Re: FirstLight Hydro Generating Company, Turners Falls Hydroelectric Project (FERC No. 1889) and Northfield Mountain Pumped Storage Project (FERC No. 2485).
Response to Comments

Study No. 3.3.1 Instream Flow Studies in Bypass Channel and below Cabot Station

Northfield Mountain Pumped Storage Project (No. 2485) and Turners Falls Hydroelectric Project (No. 1889)
Study Reports Comments and Responses

Attachment A: Elevation Duration Curves of Sea Lamprey Spawning Nests below Vernon Station

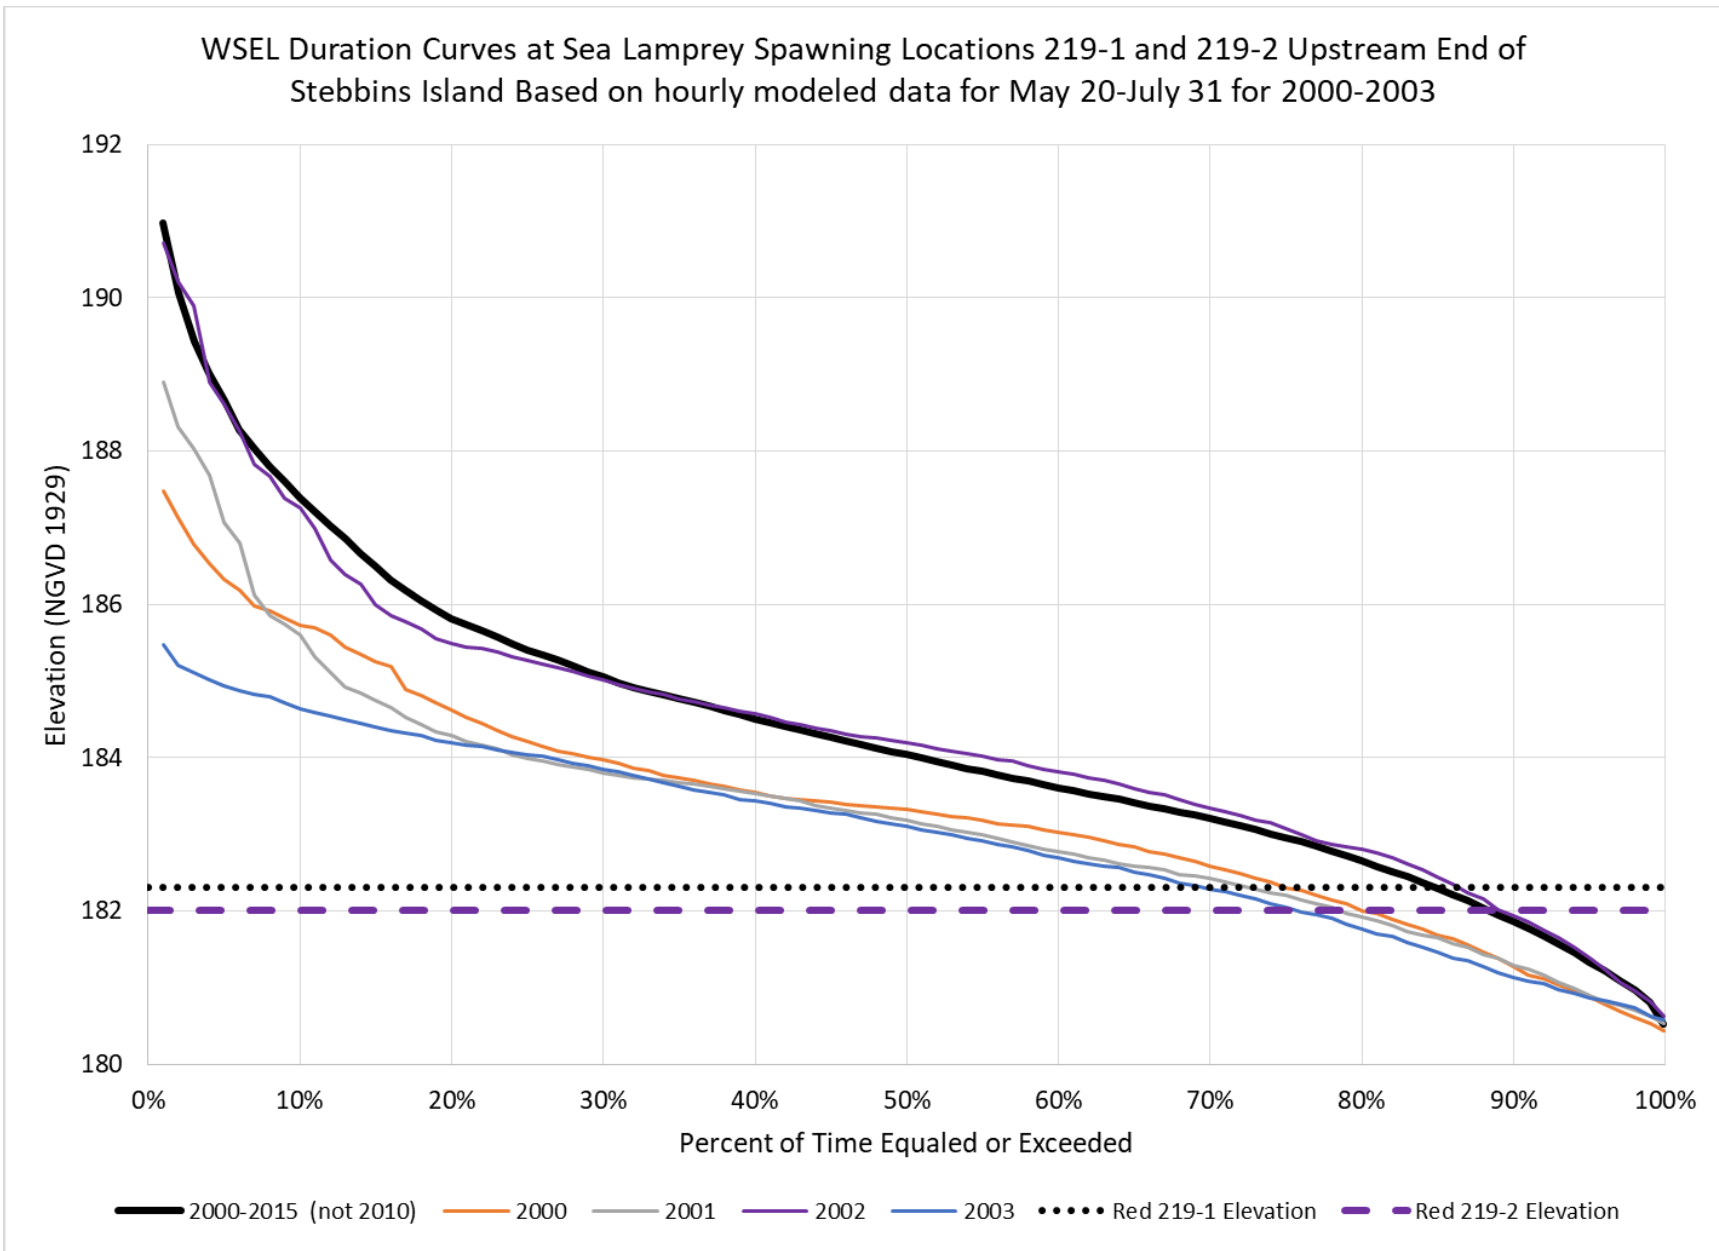
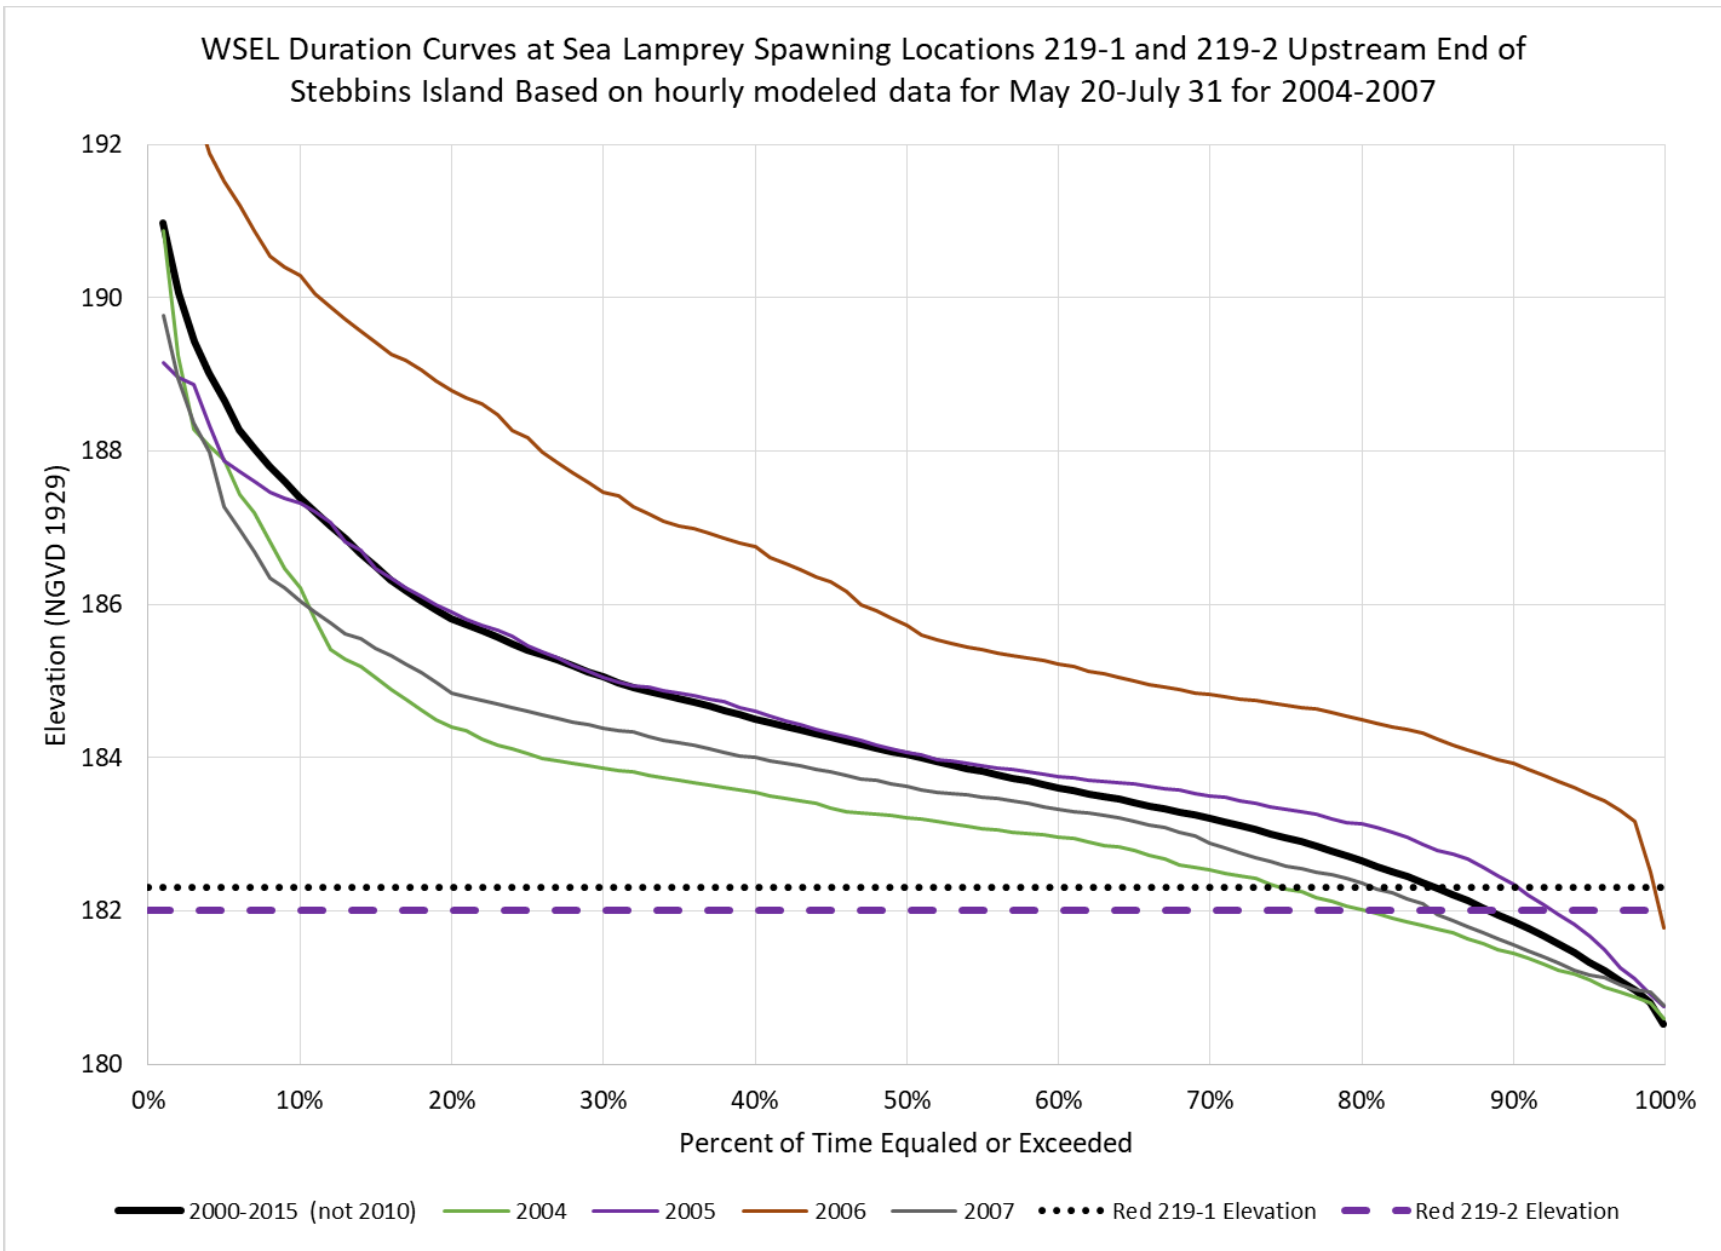
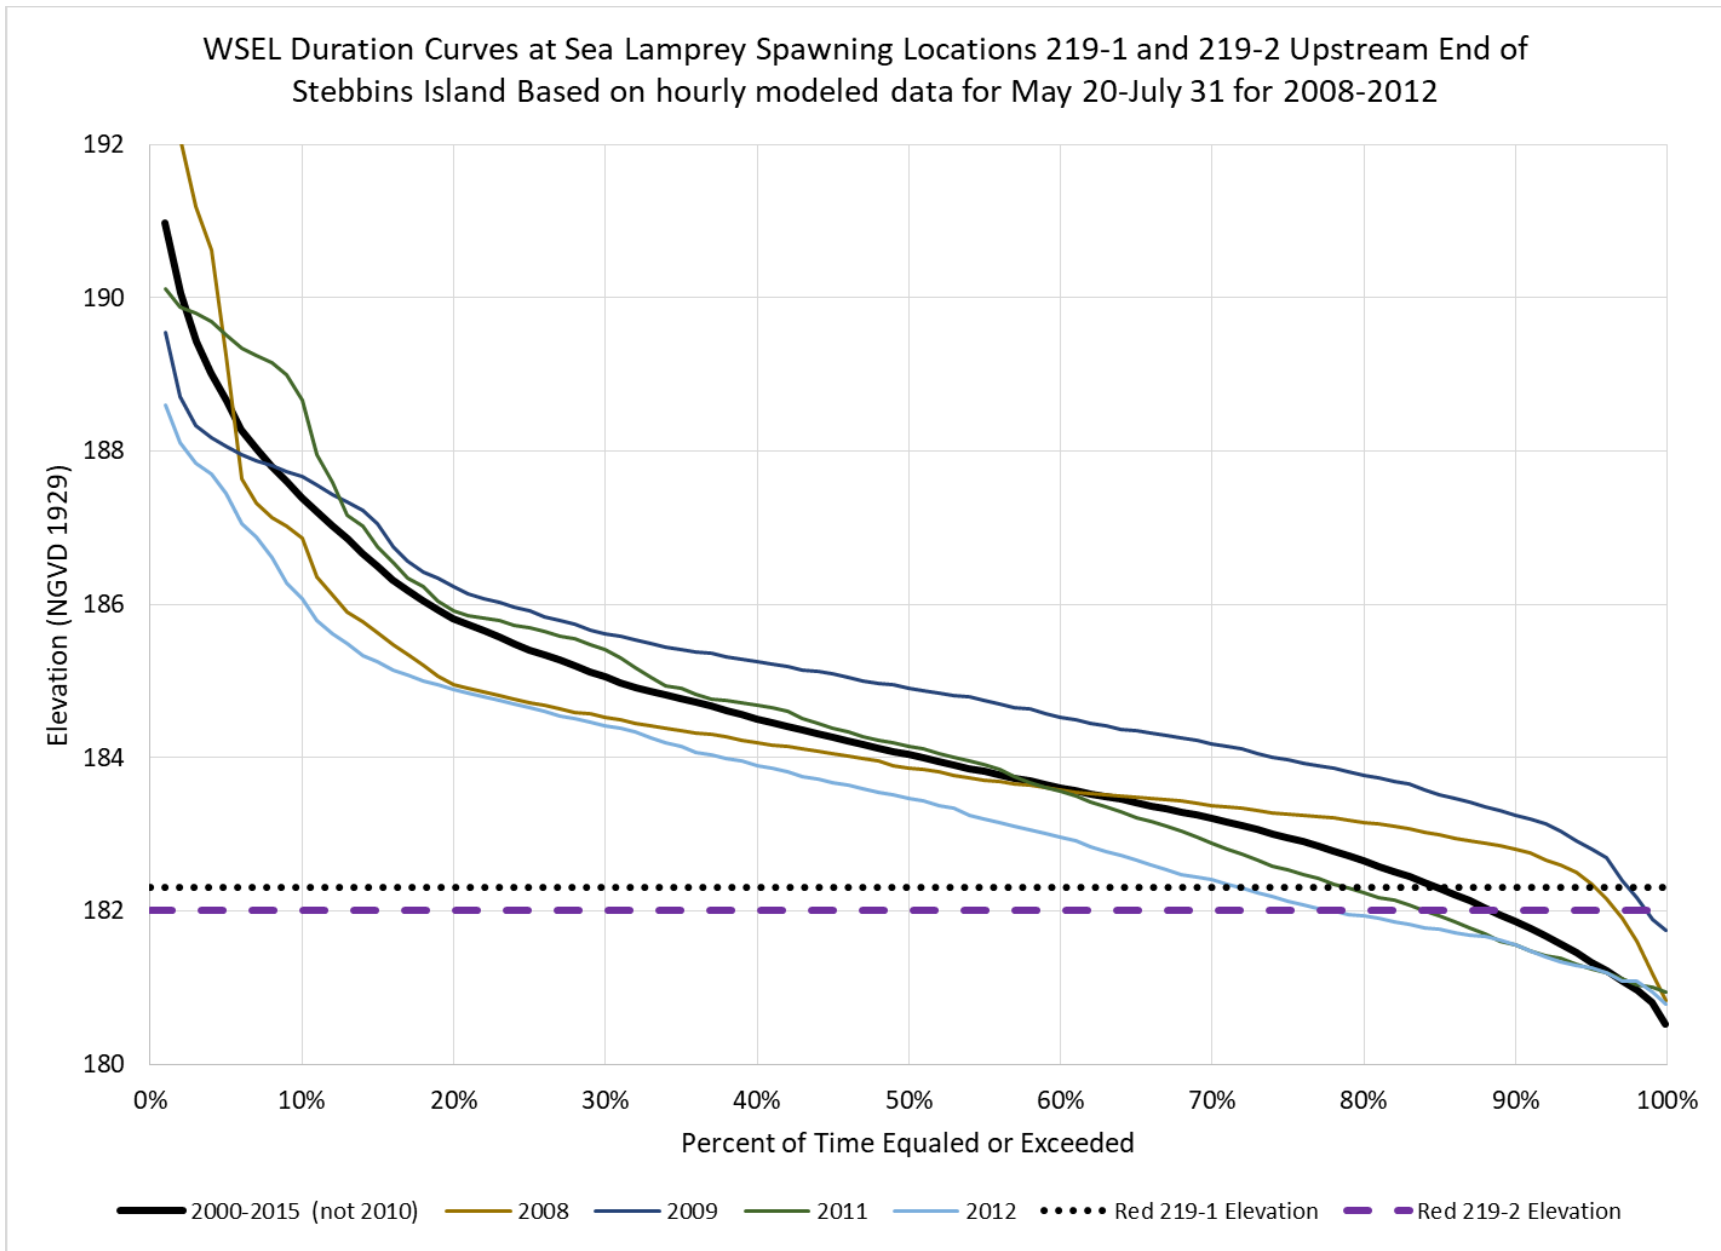
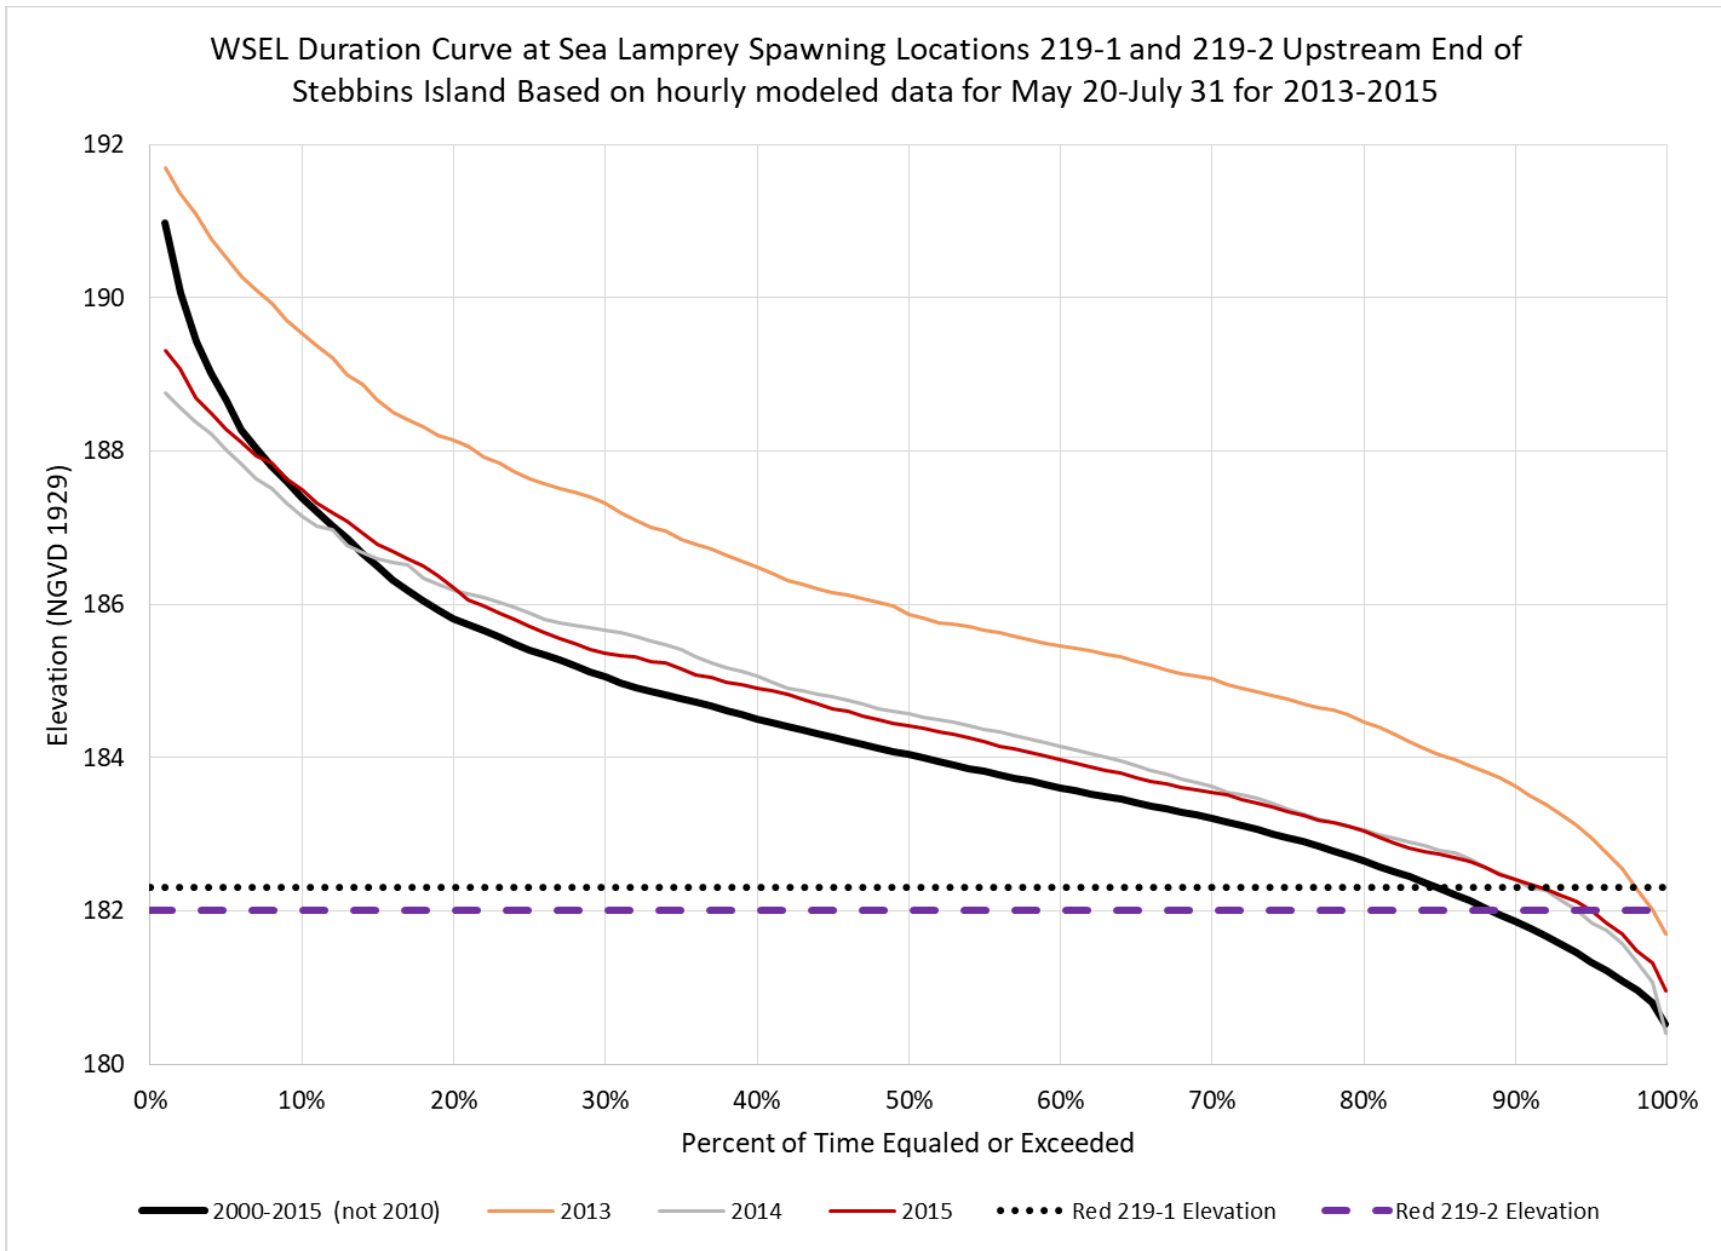
Commenter	Comment	Response
USFWS-1	<p><u>Re: Sea Lamprey Spawning Survey</u> Addendum 1 to this study focused on assessing inundation and exposure at the seven sea lamprey redd locations documented in the vicinity of Stebbins Island during the 2015 field surveys associated with Study 3.3.15. Redd bed channel elevations were compared to water surface elevations (WSELs) at the closest HEC-RAS transect to a particular redd and evaluated at an hourly time step for the period January 1,2000 through September 30,2015. For the three transects closest to the redds, hourly WSELs from May 20 to July 31 (the sea lamprey spawning period) were used to develop WSEL duration curves.</p> <p>Based on the analysis, two redds were dewatered approximately 11 to 14 percent of the time, two were dewatered 5 to 8 percent of the time, and three were dewatered about 1 to 2 percent of the time. According to FL, redd dewatering is a function of releases from the Vernon project (FERC No. 1904) as well as water surface elevations in the Turners Falls Impoundment (in addition to other variables).</p> <p><i>Comments & Recommendations:</i> Figures 2-2 (nests 219-1 and 219-2),2-3 (nests 182 and 217) and 2-4 (nests 220, 221,and 222) portray water surface elevation duration curves based on hourly modeled data for the period May 20 through July 31, with one curve representing 15 water years (2000 through 2015). In order to better understand how interannual variability may influence the amount of time WSELs are below the redd bed elevations, we request that FL revise each figure to have separate curves for each water year.</p>	<p>3.3.15 Attachment A includes elevation duration curves for nests 219-1 and 219-2, nests 182 and 217 and nests 220, 221, and 222 for individual years from 2000-2015 (excluding 2010 in which NFM was inactive). The water surface elevations are based on hourly hydraulic modeling.</p>

NMFS-1	<p><u>Re: Sea Lamprey Spawning Survey</u> FirstLight revise each figure to present separate curves for each water year to present the annual variability. Separating the annual data will better depict annual variability and the time WSELs are below the redd bed elevations. This output will help evaluate the potential affects that project operations have on sea lamprey spawning and productivity.</p>	<p>See USFWS-1.</p>
